<b>LRB-2020-13 – 19/01781/FLL - Erection of a dwellinghouse, land 40 metres north west of Carraig Mhor, Sauchie Road, Crieff</b>
--

**PAPERS SUBMITTED  
BY THE  
APPLICANT**

## Proposed Site Plan

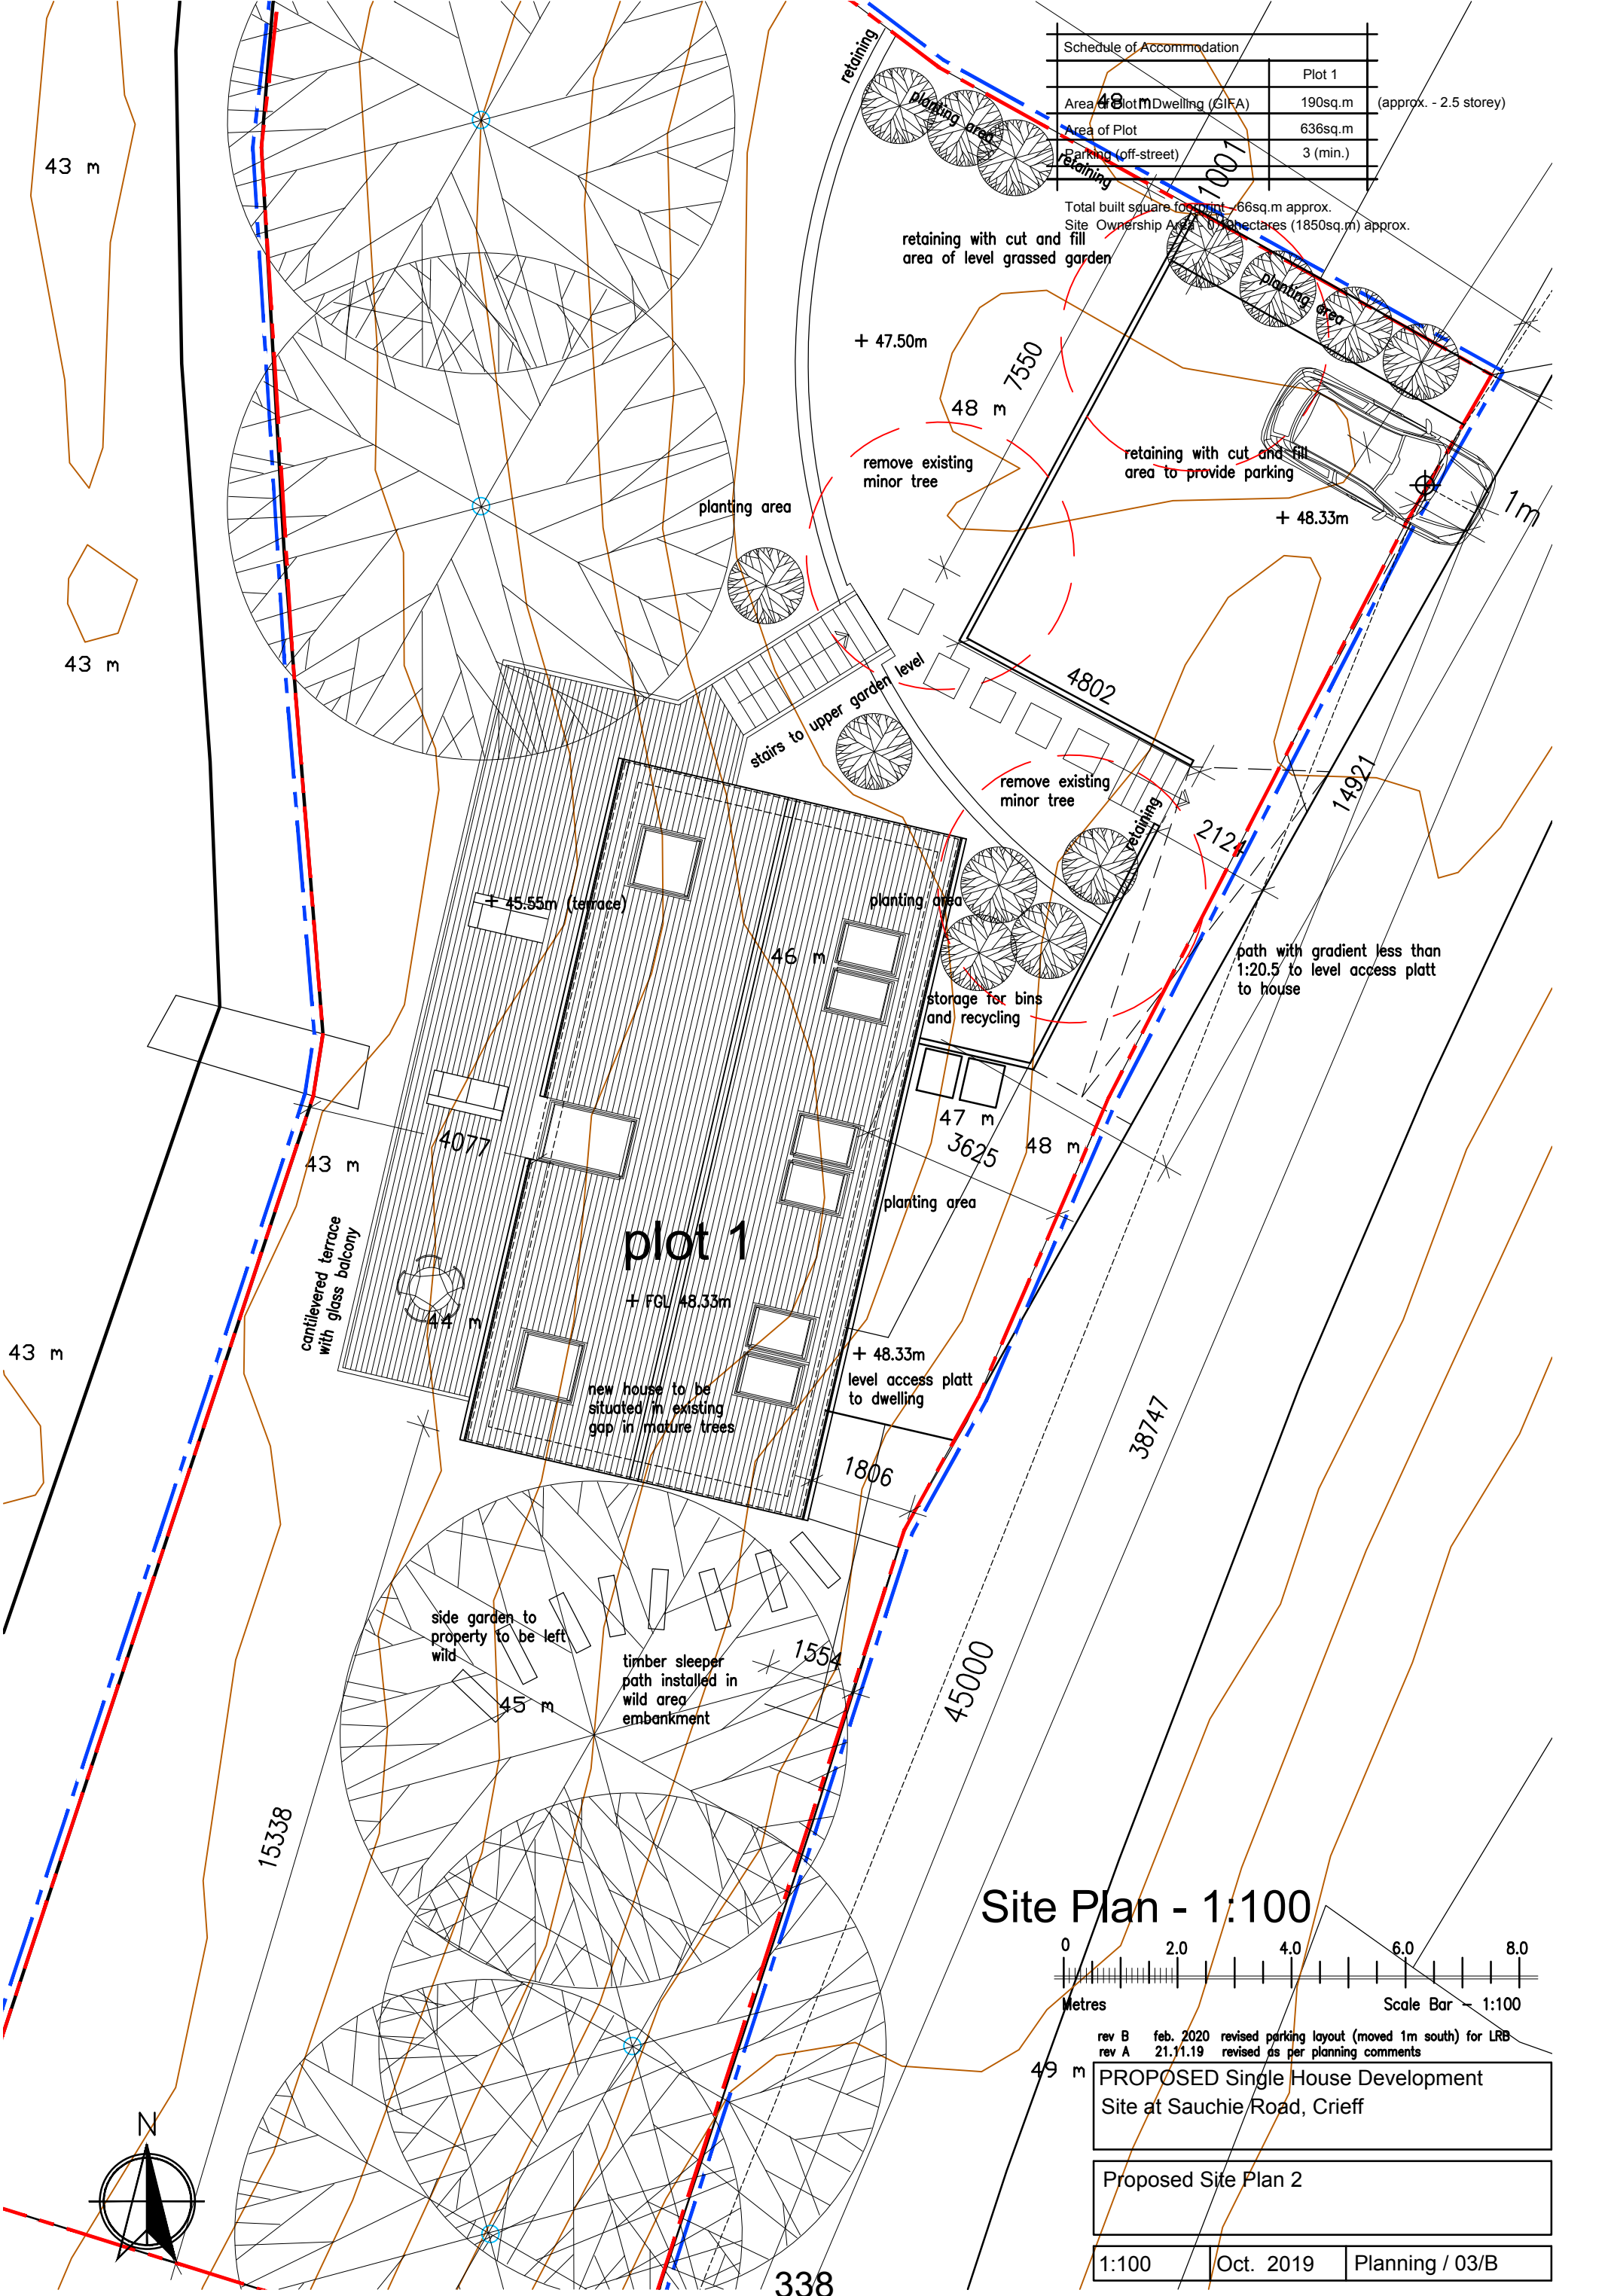
***6. The proposal is contrary to Policy 60B of the Perth and Kinross Local Development Plan 2019 as the parking area as shown on the proposed plan does not allow for vehicles to turn and access the carriageway in a forward gear, and the location of the parking area is immediately adjacent to an existing neighbouring fence which will impact considerably on forward visibility.***

The parking area as shown on the proposed plan does not allow for vehicles to turn and access the carriageway in a forward gear.

- It is noted that the planning officer who was appointed to this case was off ill during the initial planning period and no request was made of the applicant in this regard and it is our assertion that this contributed to not having the opportunity to address this during the application itself. We attach a revised site layout plan, which shows the slightly amended parking arrangement and achievable visibility splays, which is in compliance, we believe. The splay requirement is actually easy to achieve and surpass due to the bends in the road at our proposed site. Maximum calculated visibility splays north are around 90m and 80m south.

rev B	feb. 2020	revised parking layout (moved 1m south) for LRB
rev A	21.11.19	revised as per planning comments

1:100 Oct. 2019 Planning / 03/A

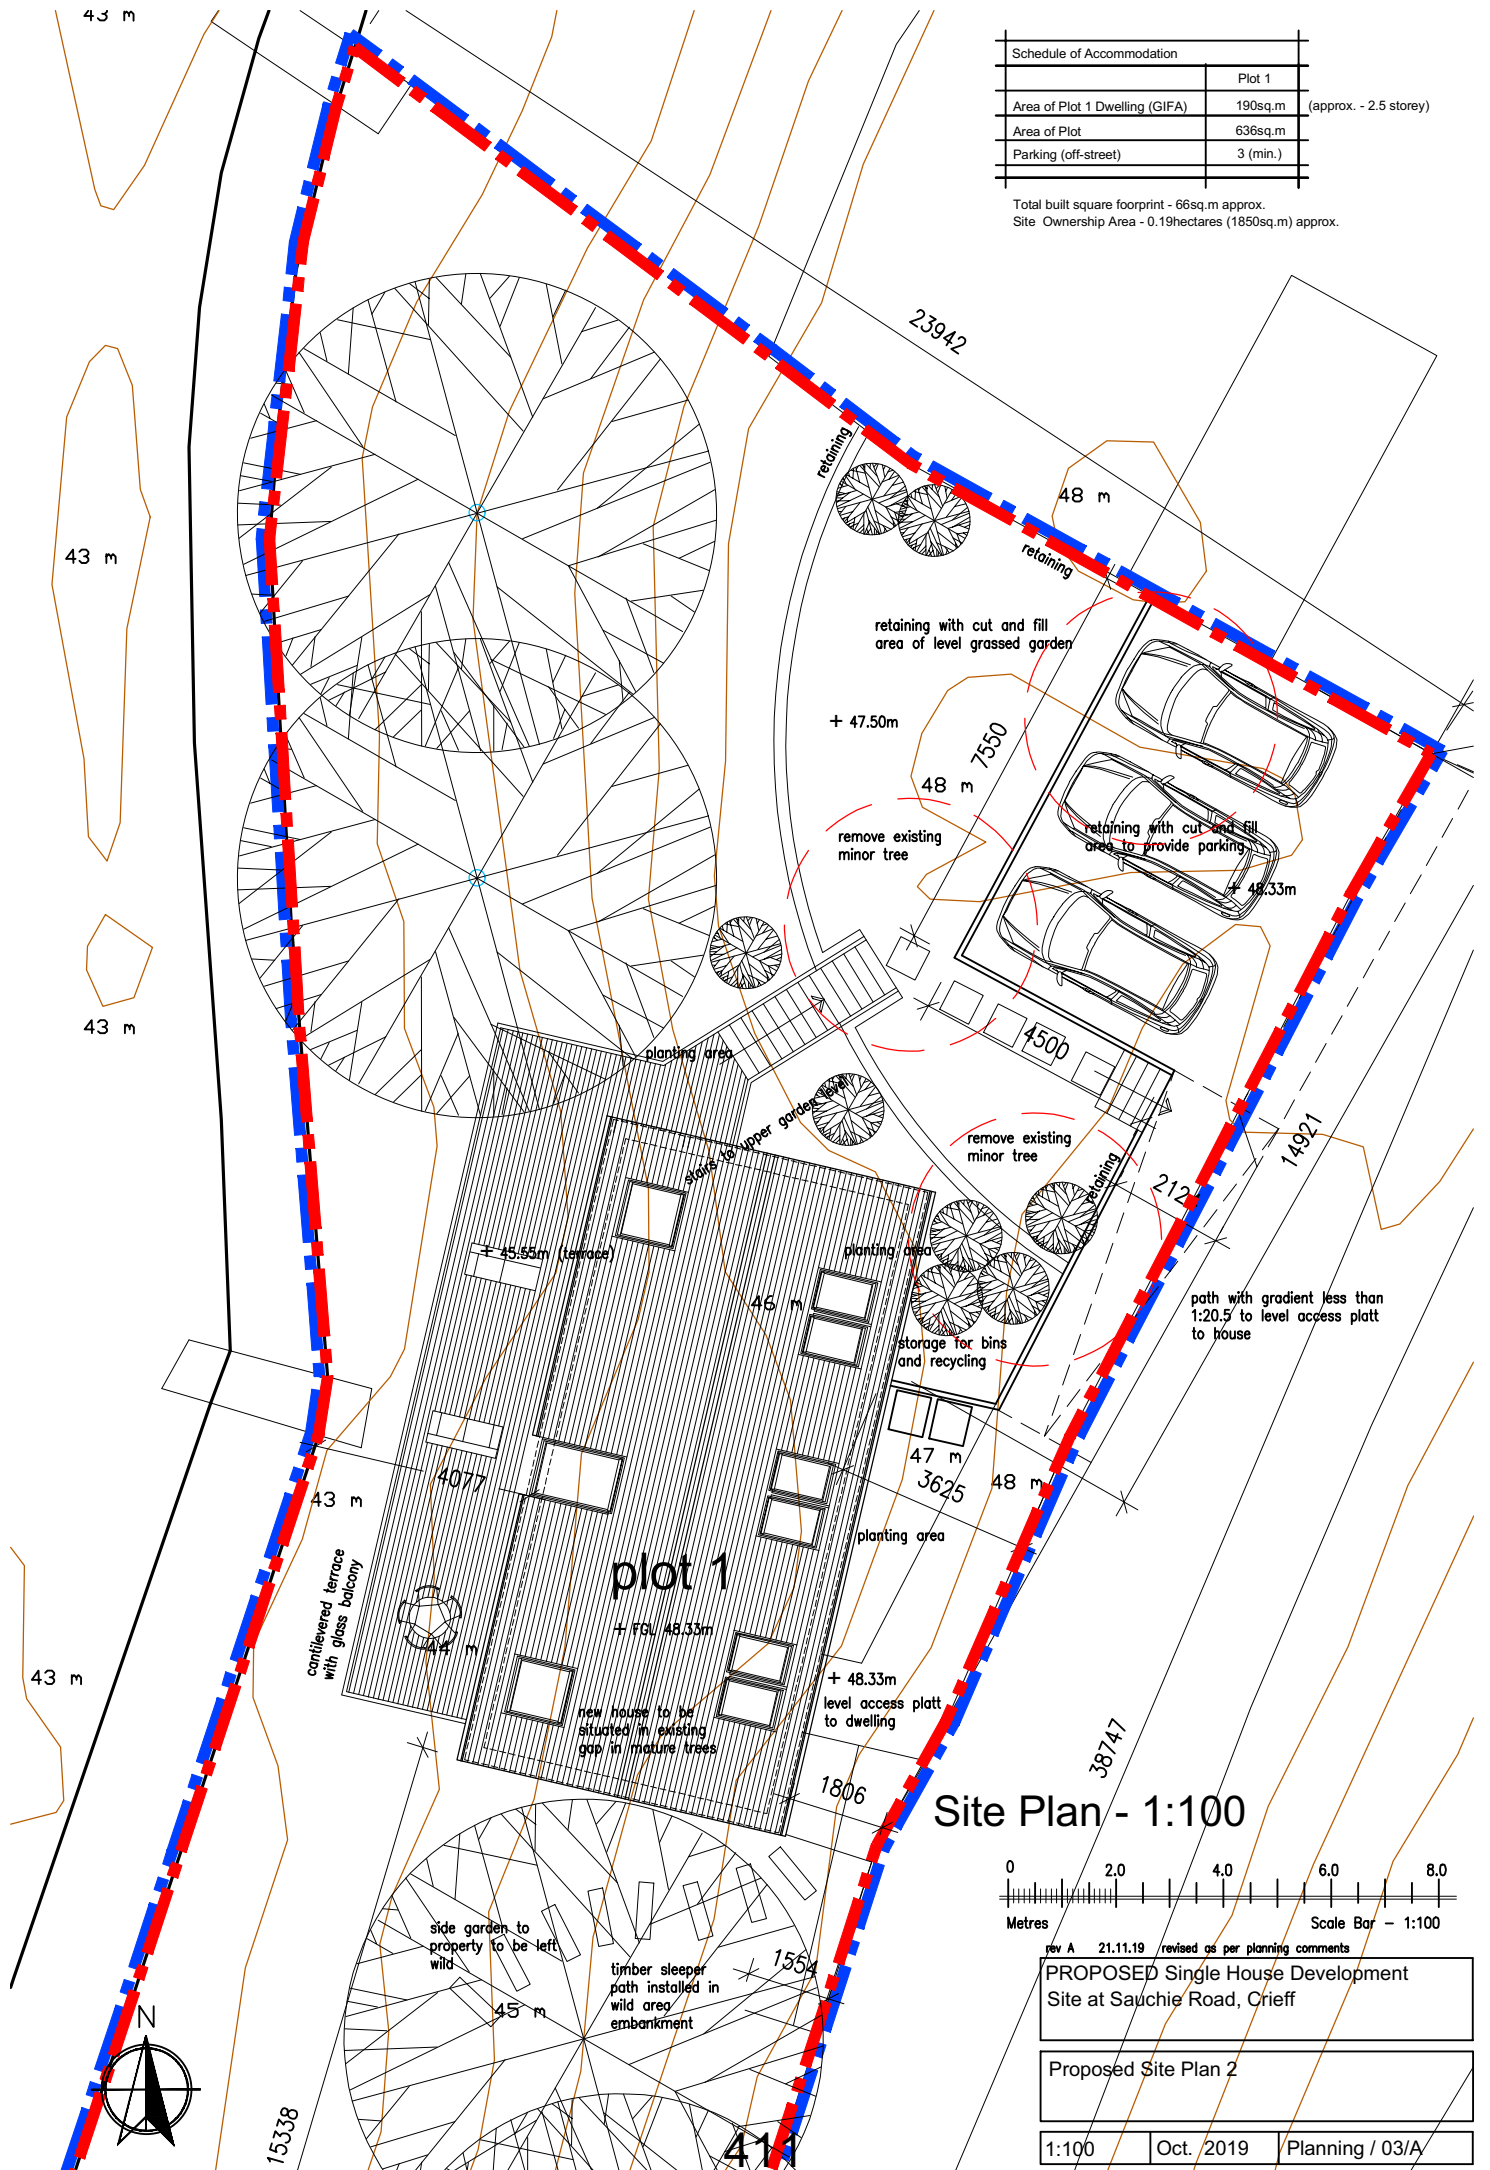
Policy 60B states that be designed for the safety and convenience of all potential users. The parking area as shown on the proposed plan does not allow for vehicles to turn and access the carriageway in a forward gear. In addition, the location of the proposed parking area is immediately adjacent to an existing neighbouring fence

The transport planning team have objected to the proposed development on two grounds. The parking area as shown on the proposed plan does not allow for vehicles to turn and access the carriageway in a forward gear and the location of the parking area is immediately adjacent to an existing neighbouring fence which will impact considerably on forward visibility.

rev B feb. 2020 revised parking layout (moved 1m south) for LRB
